**Historic Architectural Review Commission
Staff Report for Item 4**

Application Number: H2023-0003

Address: 10 Lowes Lane

Renovations to existing house. New side addition. New pool deck and site improvements.

PROPOSED SITE PLAN
SCALE: 1/16" = 1'-0"

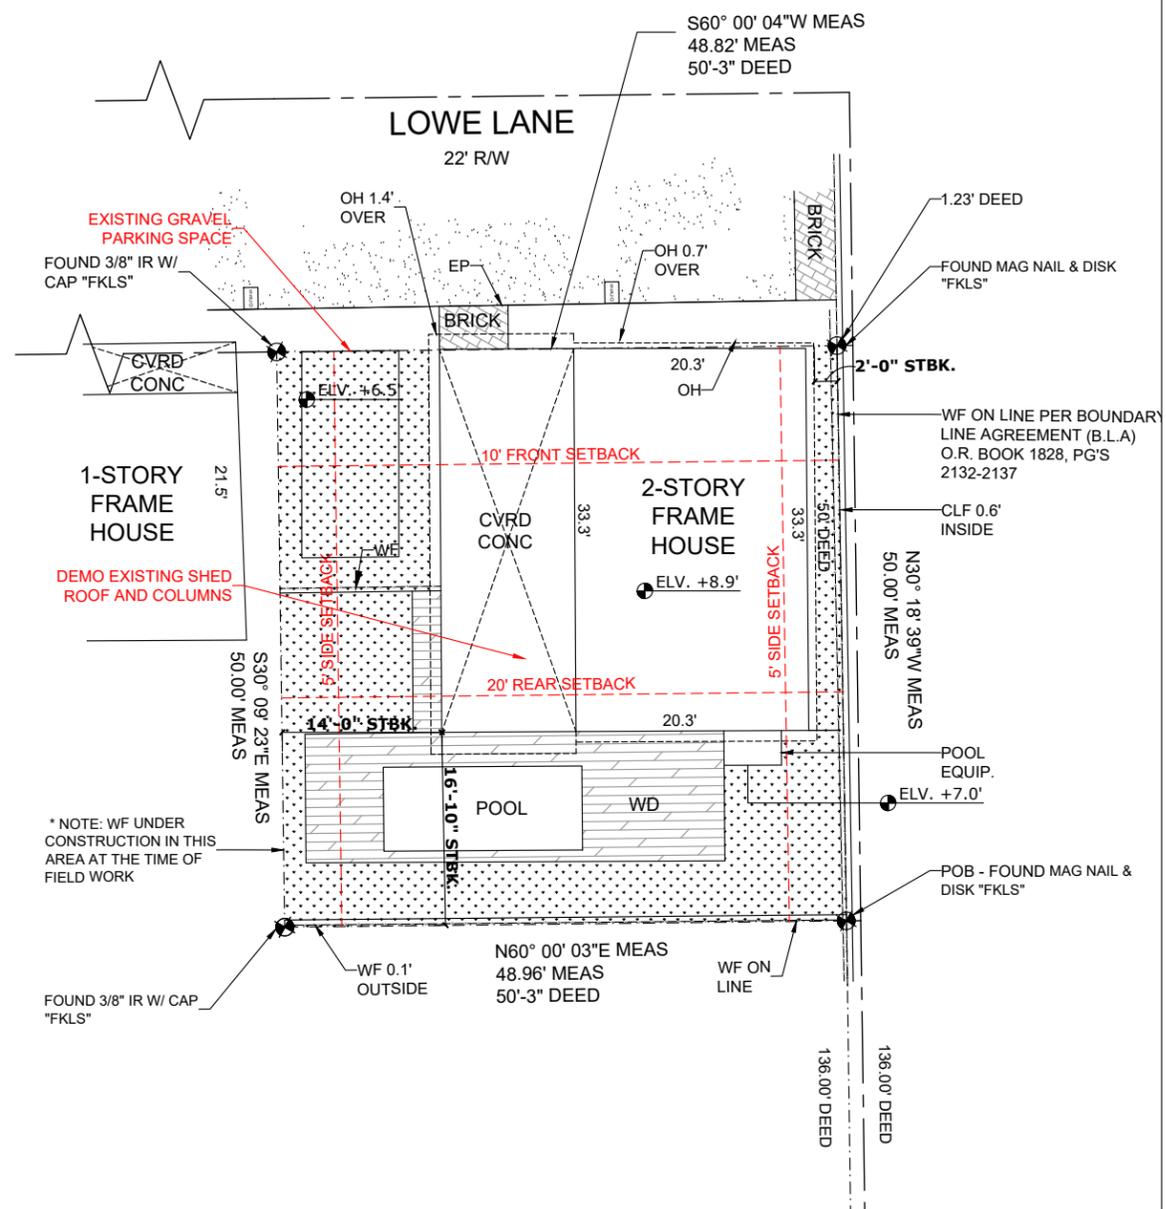
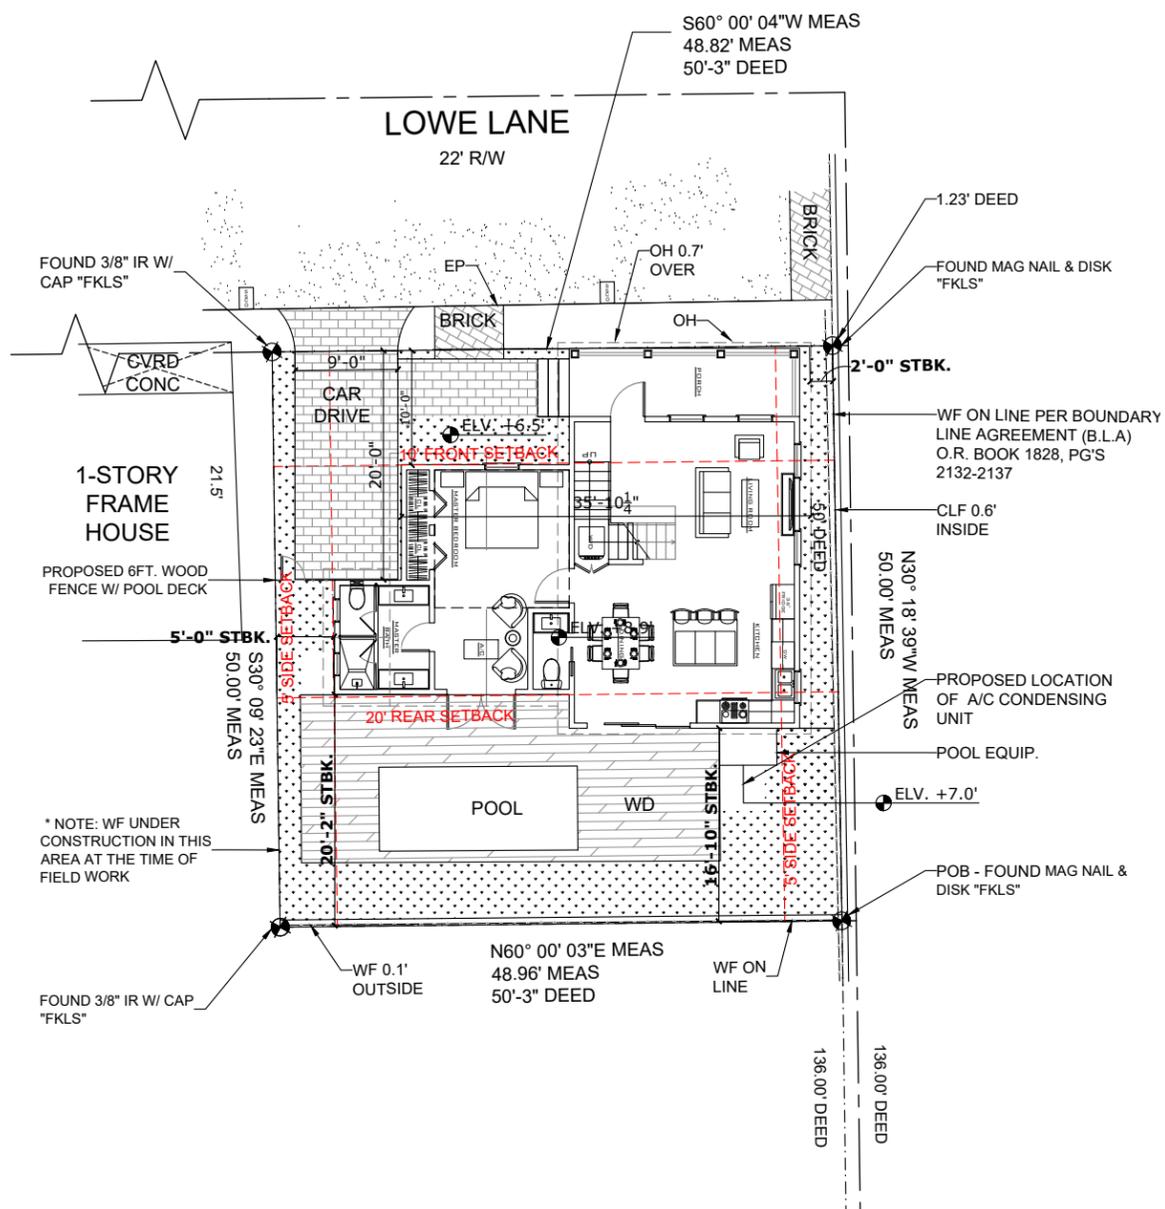
A pool deck is proposed behind the house and the addition and will not be visible from the street.

It is staff's opinion that the proposed design conforms with cited guidelines. The new proposed porch was designed based on the circa 1965 photograph that depicts the character defining feature as a 3 bay porch. Although the side addition is larger than 30% of the floor area of the main house, it is replacing an existing addition. The scale, mass and proportions of the new addition are in keeping with similar land use structures within the area and the addition will not overshadow the existing historic house. The proposed pool deck will be at the rear and behind the house.

PROPOSED FRONT ELEVATION
SCALE: 3/16" = 1'-0"

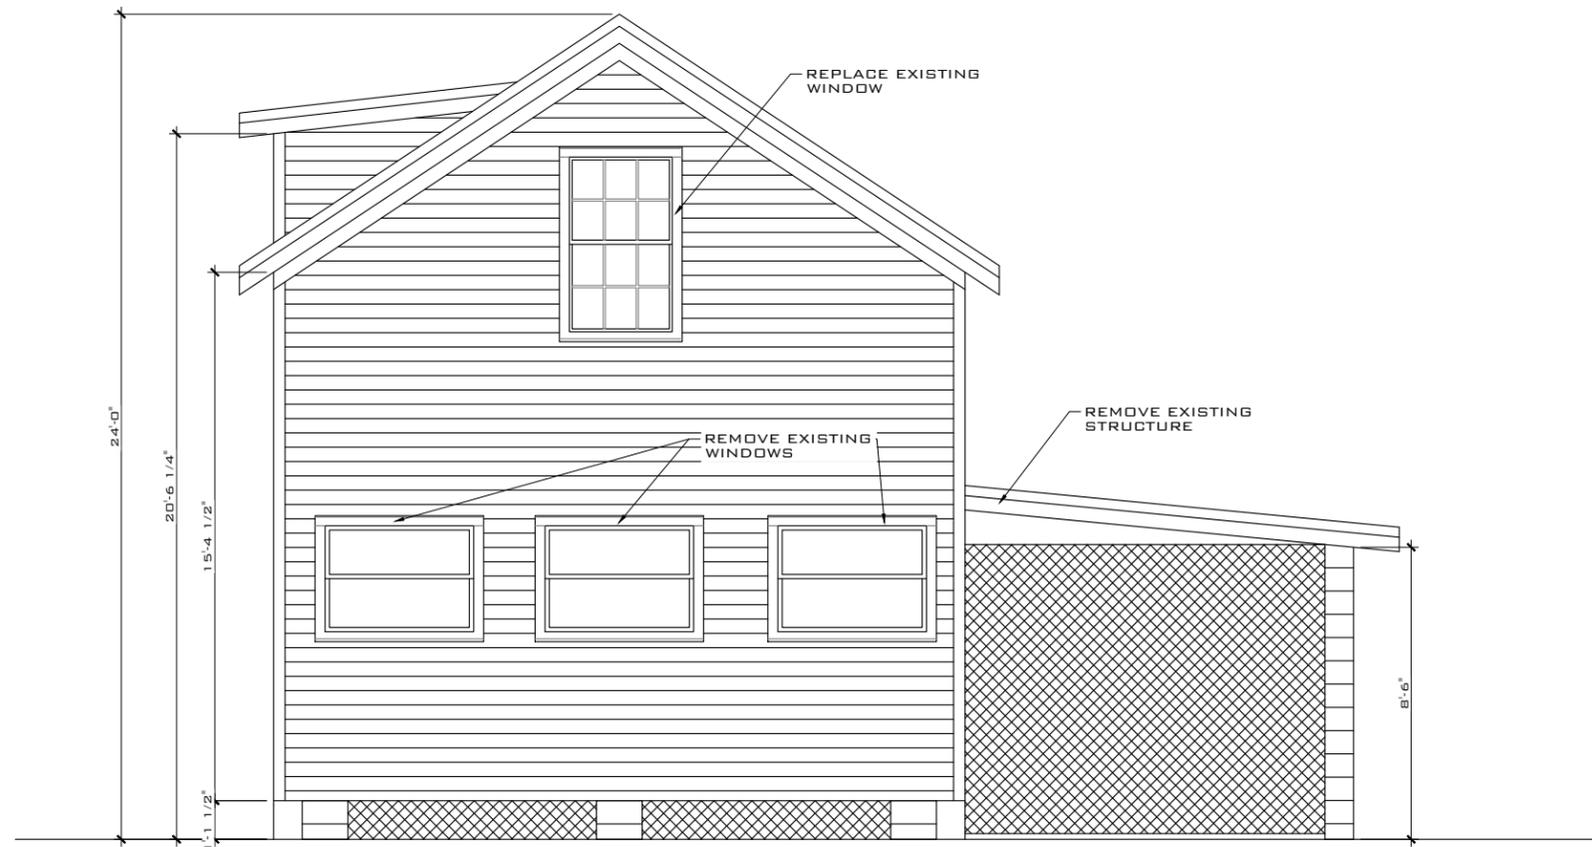
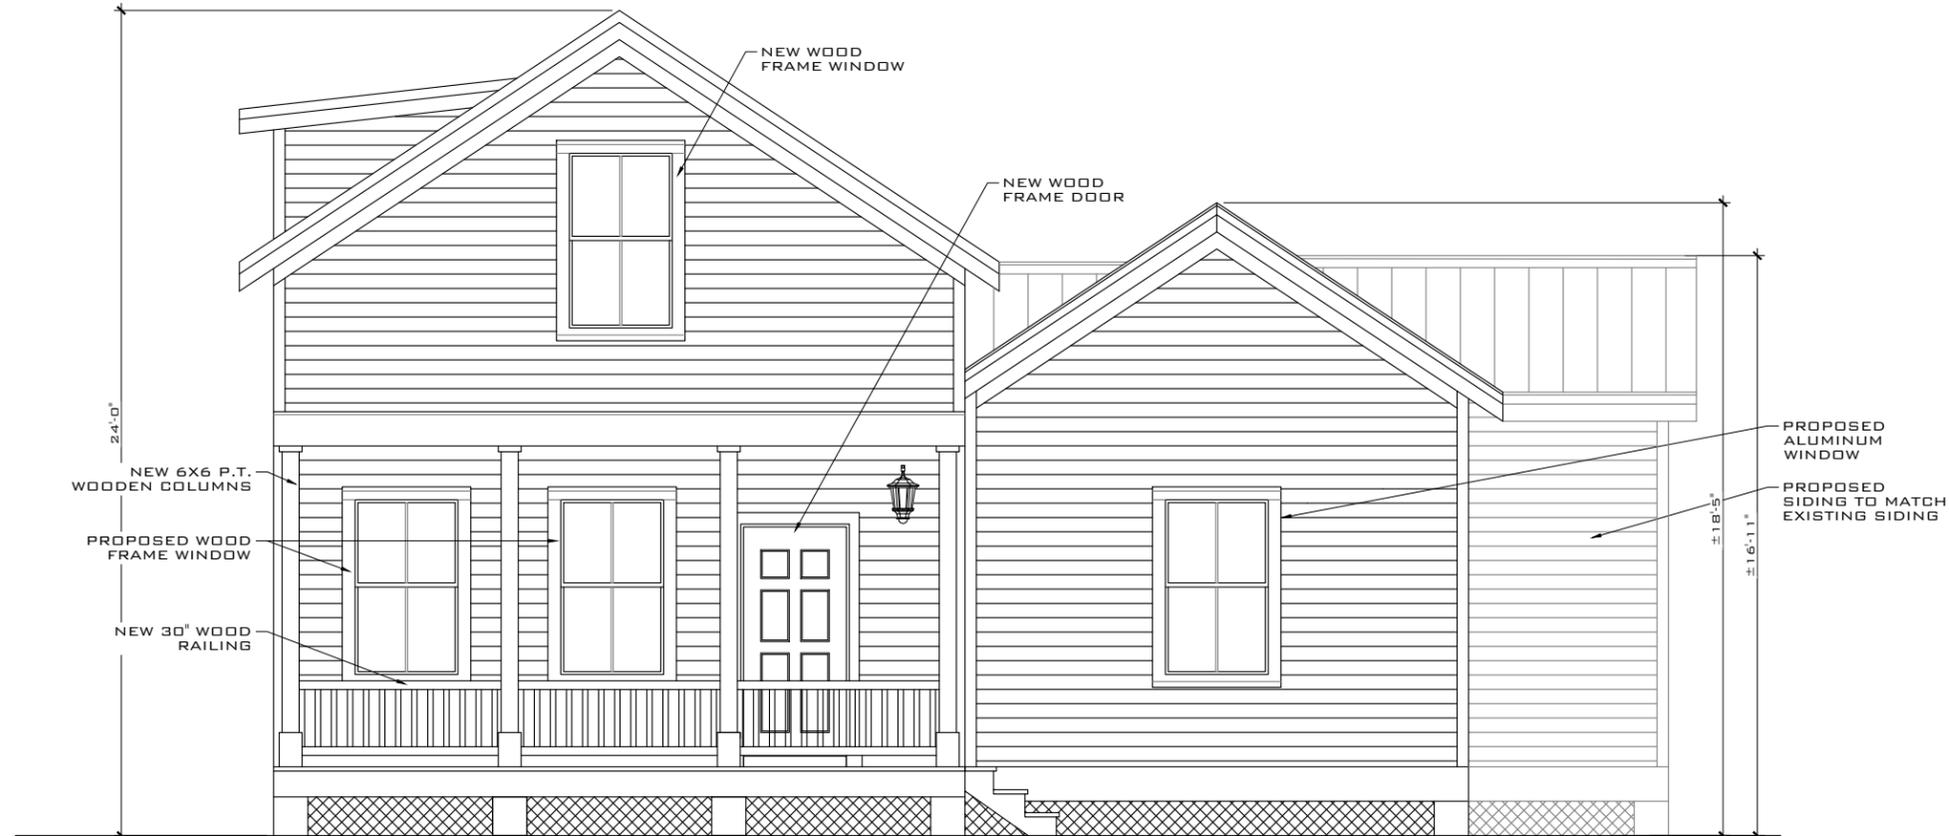
A Certificate of Appropriateness under review is for renovations to a historic house, which includes the reconstruction of the front porch, which is completely enclosed. The new front porch will have three bays, as the one depicted in the circa 1965 photograph, and all components will be wood. The plan also depicts a new one-story addition that will replace an existing side attached structure. The new addition will differ from the existing one in roof forms and setbacks, having the new addition a 10' setback from front property line. The addition will have a small bump-out on the rear west side to accommodate parts of a full bathroom. The new addition will have wood lap siding, aluminum impact windows and 5 v-crimp metal roofing system.
